**RUIDOSO-RUIDOSO DOWNS REGIONAL WWTP
JOINT USE BOARD**

**PHASE 1A – SLUDGE HANDLING AND
ULTRAVIOLET DISINFECTION
FACILITIES – 2008**

CHANGE ORDER NO. 04

PROJECT: Ruidoso-Ruidoso Downs Regional WWTP – Joint Use Board Phase 1A Sludge Handling and Ultraviolet Disinfection Facilities - 2008

**SD INLET
LOCATION**

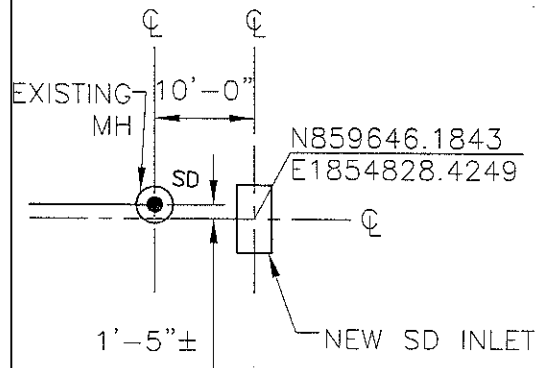
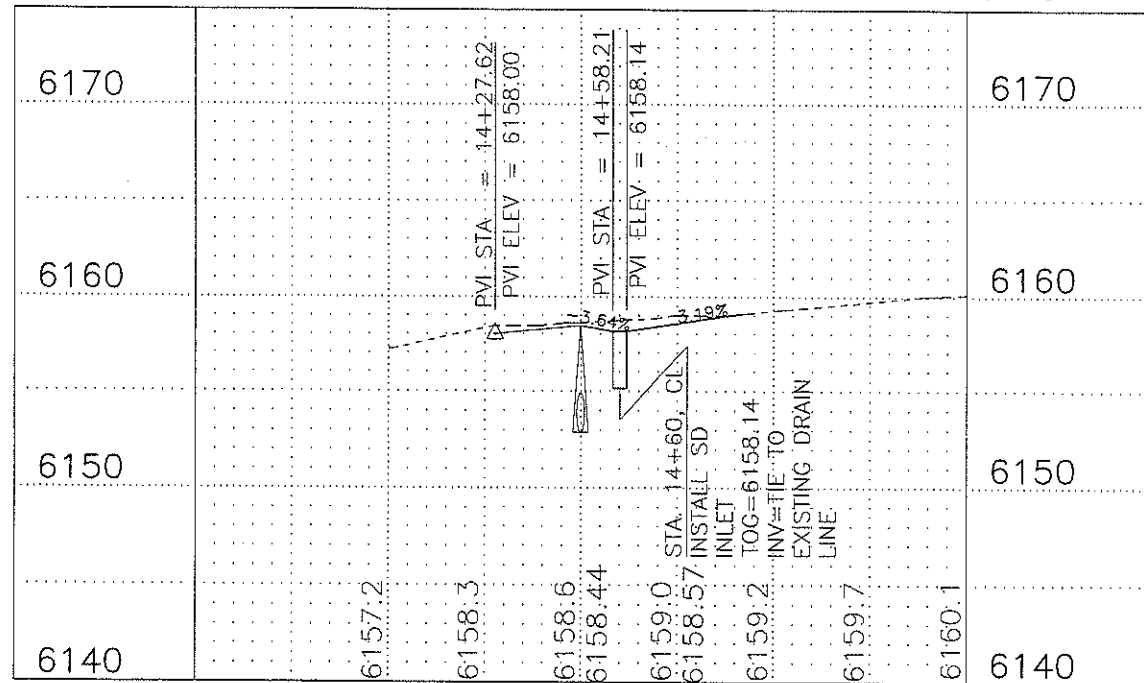
A. SCOPE AND JUSTIFICATION: The sludge storage area surface runoff drop inlet was removed by the Contractor. Afterwards, Bobby Snowden, Plant Operator identified the need for retaining the drop inlet to capture and return surface runoff from the sludge storage area to the head of the treatment plant. The previous drop inlet location was changed to fit the new drainage and grading plan. In addition, the west portion of the sludge drainage area required to be regraded to capture surface runoff in the new drop let. The area of the western portion is approximately 353 square yards. The Contractor's price proposal is based on the Engineer's grading plan of July 15, 2009 (copy attached). The revised grading plan is to accommodate the new location of the sludge storage area drop inlet.

- ① STA. 14+60, CL
INSTALL SD INLET
TOG=6158.14
INV=TIE TO EXISTING
DRAIN LINE
- ② SAWCUT, REMOVE,
DISPOSE & REPLACE
EXISTING ASPHALT.
MATCH EXISTING

UV DIS unit EXTRA sidewalk

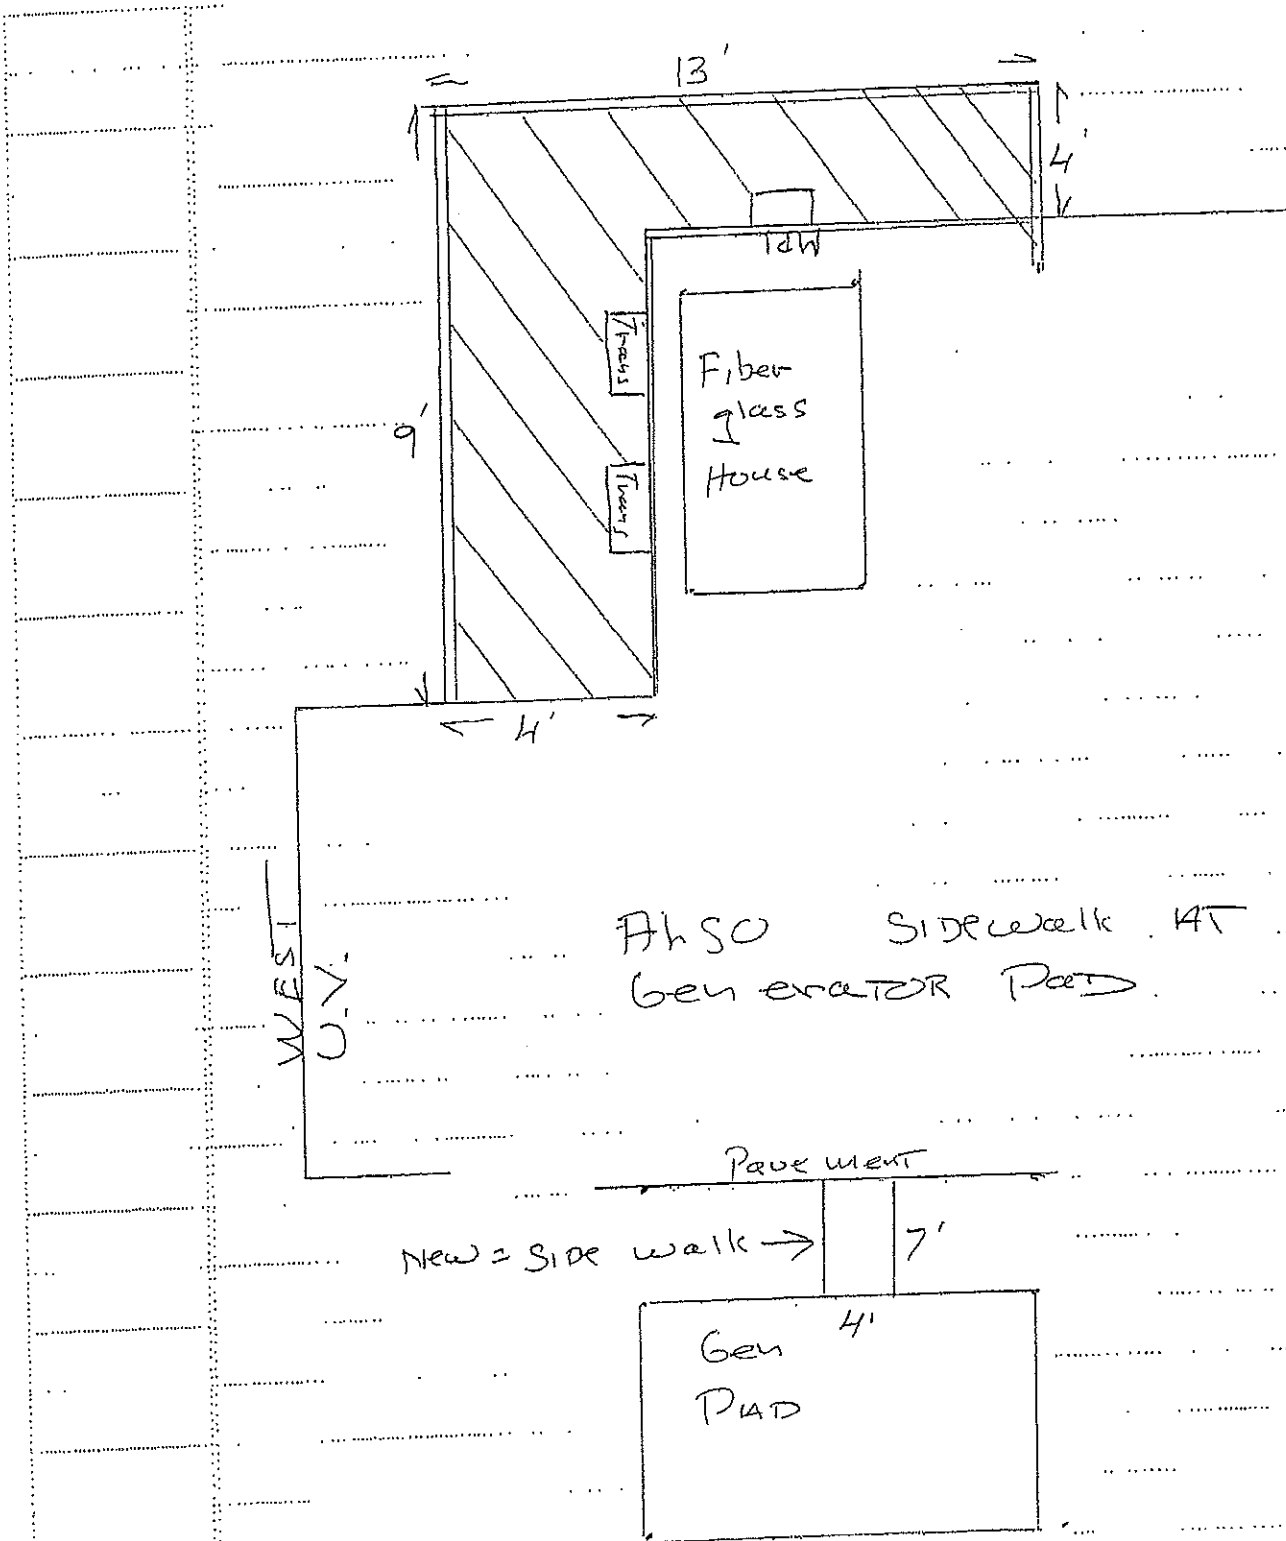
A. SCOPE AND JUSTIFICATION: The plant operators have raised a concern regarding access to the UV Control Panel located at the NW corner of the structure. Presently the area is to be filled with large rip-rap rock.

Access will not be very frequent and the sidewalk will make it easier for the Operators. Bobby Snowden, plant operator request for the Engineer to consider a sidewalk to accommodate easier access to the UV Control Panel. The attached drawing shows the limits of the additional 18 linear feet of sidewalk.

Also Sidewalk AT
Generator Pad

<p>W30-101CH</p> <p>SHEET 9/03/08</p>	<p>YARD PIPING EAST AREA CHANGE REQUEST - MOVE PROPANE TANK</p>

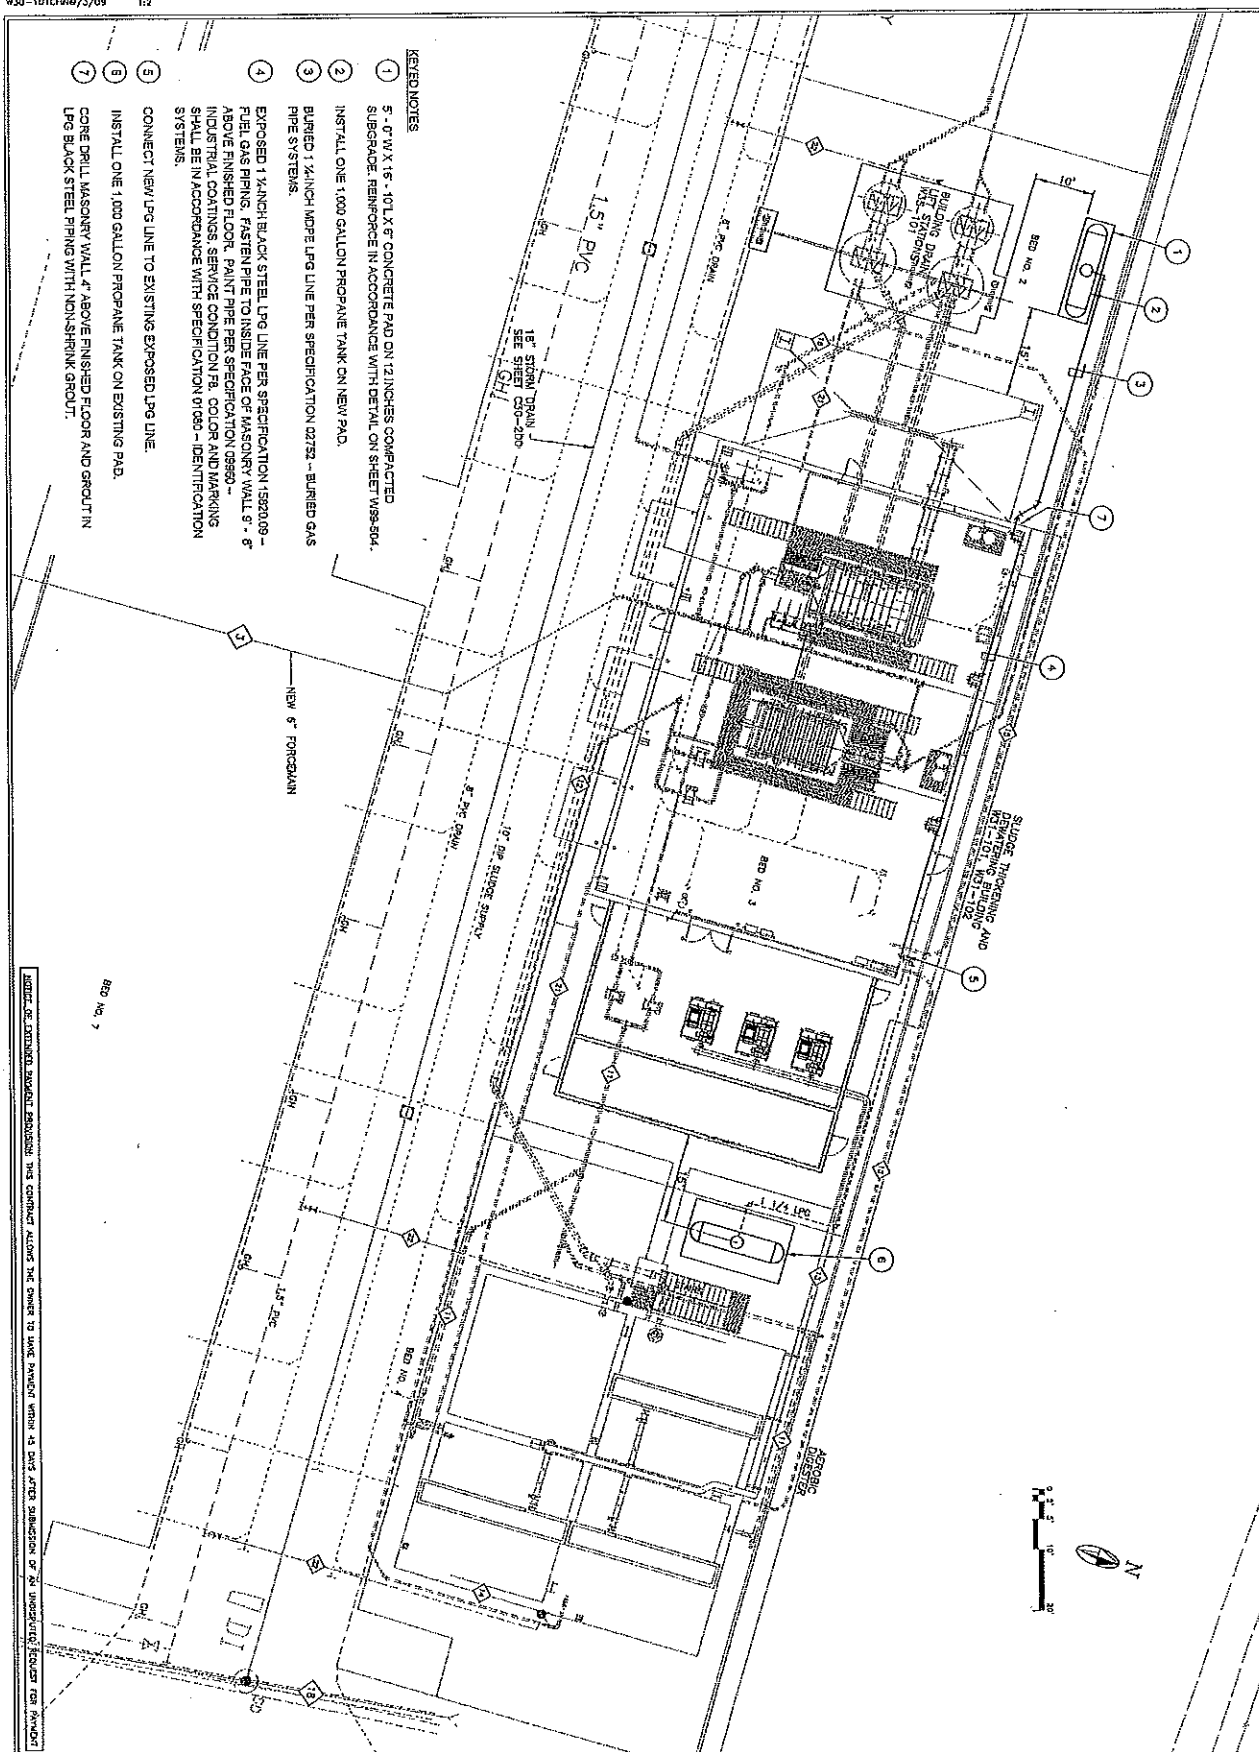
A. SCOPE AND JUSTIFICATION: The design drawings show the installation of two parallel propane tanks located between the new building and the new digester (Drawing W30-101). The treatment plant site is very congested with existing treatment structures and with limited space to construct the new facilities over the existing sludge drying beds.

Description: Relocate one propane tank as shown on drawing W30-101CH sheet 9/03/09.

Re route 1-1/4" LP Gas line per drawing W30-101-CH
